**RE: Amendment to the Sealed Source Registration NR-0220-S-112-S**

I am writing to request an amendment to the Registry of Radioactive Sealed Source and Devices Safety Evaluation of Sealed Source for the C-337A source registration number NR-0220-S-112-S to allow the use of this source assembly in the Sentinel 880 family of exposure devices. The registration for the C-337A source assembly already authorizes the use of this source in the similar Amersham 660 family of exposure devices.

## APPENDIX 1. REAR PLATE ASSEMBLY

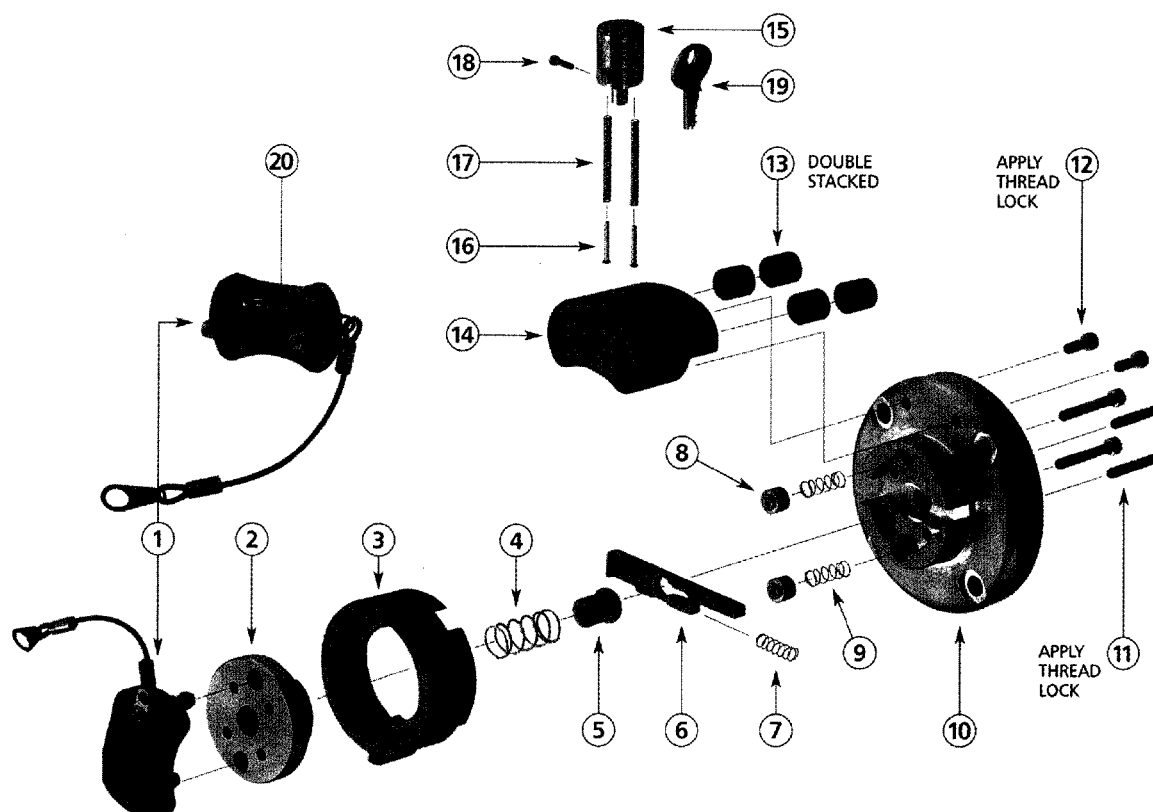
While the external features of the Sentinel 880 are different from the Amersham 660, the features of the posi-lock are similar. The essential elements of the posi-lock are shown in the attached rear plate assembly schematic. (Appendix 1.) The rear plate assembly consists of a lock slide(6) that secures the source assembly. The lock slide can only be moved when the selector ring(3) is in the OPERATE position.

Movement of the lock-slide(6) into the release position is resisted by a spring (7). However, once the lock slide is fully inserted, it engages a spring-loaded sleeve(5). This allows the source assembly to be released by the operator. Once the exposure is completed, the source assembly is retracted into the projector. As the source assembly returns to the posi-lock, its locking ball engages the sleeve, causing it to disengage from the lock slide, which, in turn, causes the source assembly to be secured. Our tests have shown the C337A to be mechanically compatible with the posi-lock. The tests consisted of 100 simulated exposure cycles using inactive source assemblies as describe in the attached test report. (Appendix 2)
